# **Orange and Region Water Security Alliance Submission on the Macquarie River to Orange pipeline project/Orange Drought Relief Connection**

Ref No: 10\_0235

14<sup>th</sup> October 2012

### **Incorrect data**

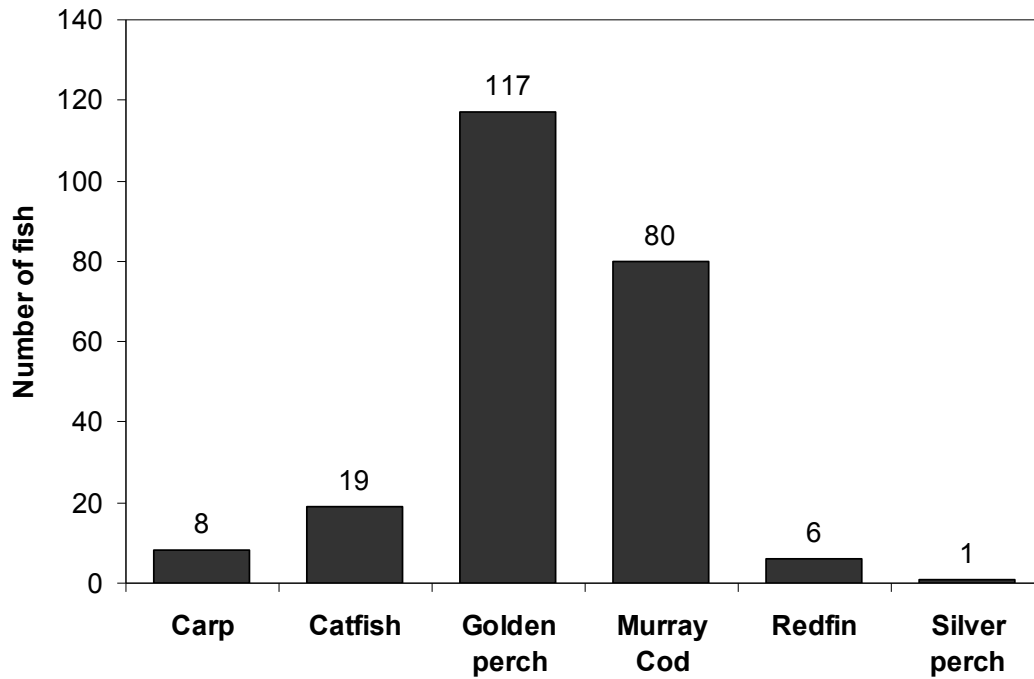
This section records the following data on fish caught:

- Six golden perch (*Macquaria ambigua*) with fork lengths of 40, 42, 43, 46, 46, 50 mm (Plate 2c) and
- one redfin perch (*Perca fluviatilis*) with a fork length of 27.5 mm (Plate 2d) were caught in the gill nets.
- No animals were caught in the baited traps."
